Ithaca Neighborhood HOUSING SERVICES

May 22, 2014

RE: Updates to the Stone Quarry Apartments Site Plan

DESIGN REVISIONS MAY 2014: VIEW OF TOWNHOUSES FROM ACROSS SPENCER ROAD

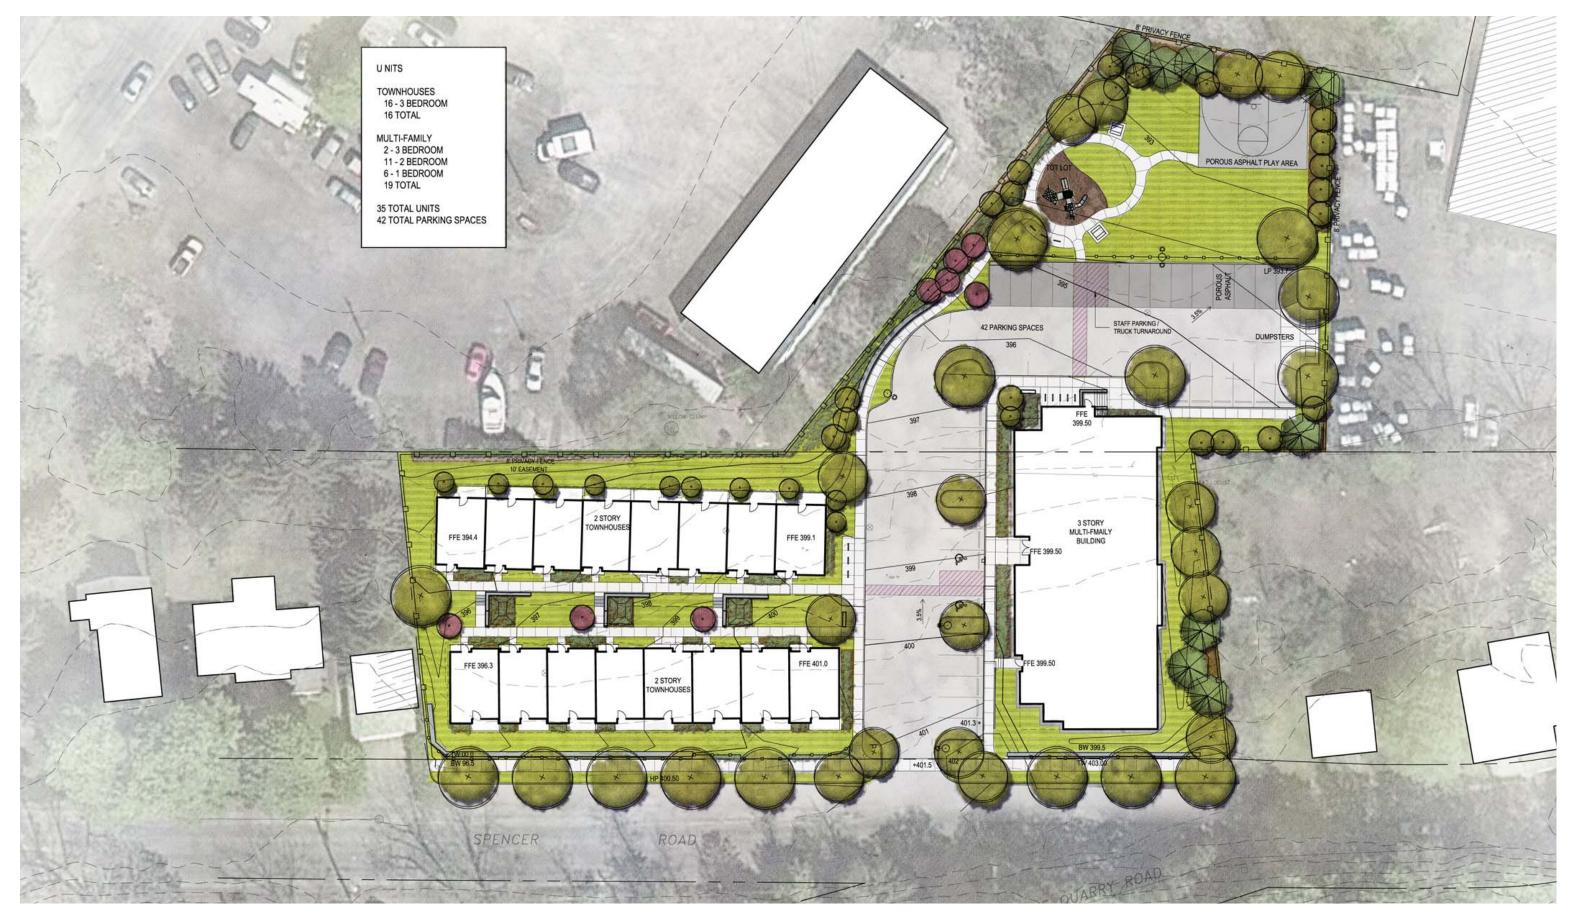
- Town House Elevations each three bedroom townhouse now steps in elevation 8 inches from North to South.
- Spencer Street Walkways there is now a change in elevation from Spencer Road to the back door of the townhouses that requires a short 4 foot retaining wall and as a result there are no walkways from the sidewalk to the back door of the townhouses. Modifications to the fence on Spencer Road were made to account for this changed access.

- The Spencer Road façade has been refined to reconcile its formal language with the rest of the architecture and a pergola added to give the project some additional visual interest and provide a location for the project name.
